IMMEDIATE ACTION REQUIRED: Vector 8611MT Multi-Temperature Trailer Refrigeration Unit

SERVICE BULLETIN

SER20-013
04/22/2020

SUBJECT: REQUIRED Vector™ 8611MT Generator Harness Inspection & Routing Correction

Figure 1

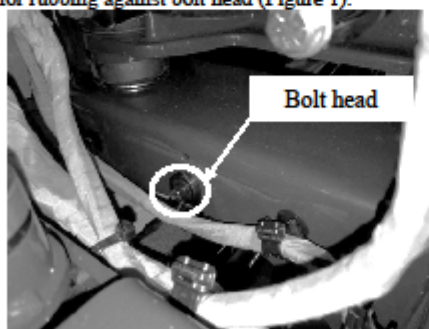
1. Inspect the generator high voltage wiring harness for rubbing against bolt head (Figure 1).

3. If the tape is not abraded to the point that wires can be seen, skip to step 7.
4. If there is abrasion to the tape or wiring insulation, but the wire insulation is not compromised, (no copper showing), skip to step 6.
5. If any of the wires have copper conductors visible, remove the cloth tape for access and cut the wire at the damage. Repair using a butt splice and two layers of heat shrink over the butt splice (1/4" and ½") per Vector Ops & Service Manual 62-11640 page 8-54.

Figure 2

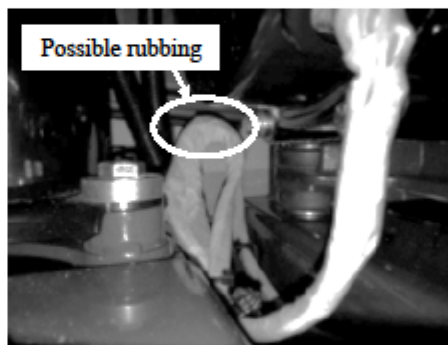
2. Inspect generator high voltage wiring harness for rubbing against generator (Figure 2).

Figure 3

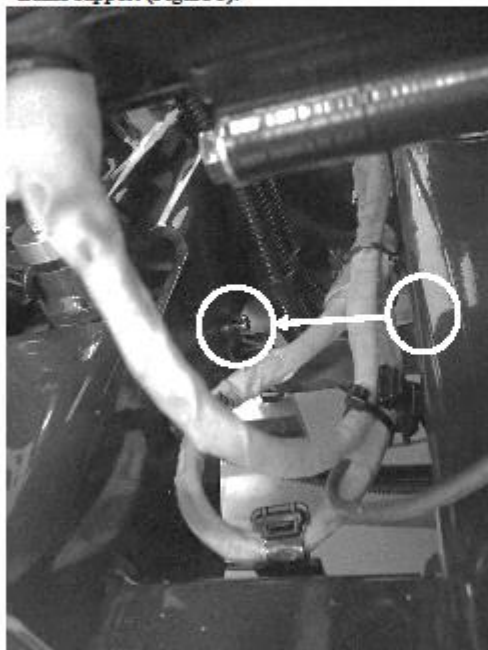
- Using orange cloth tape, wrap the section of the generator wires from the generator to the main harness.
- Relocate the low voltage harness support and bolt from the generator frame support to the compressor frame support (Figure 3).
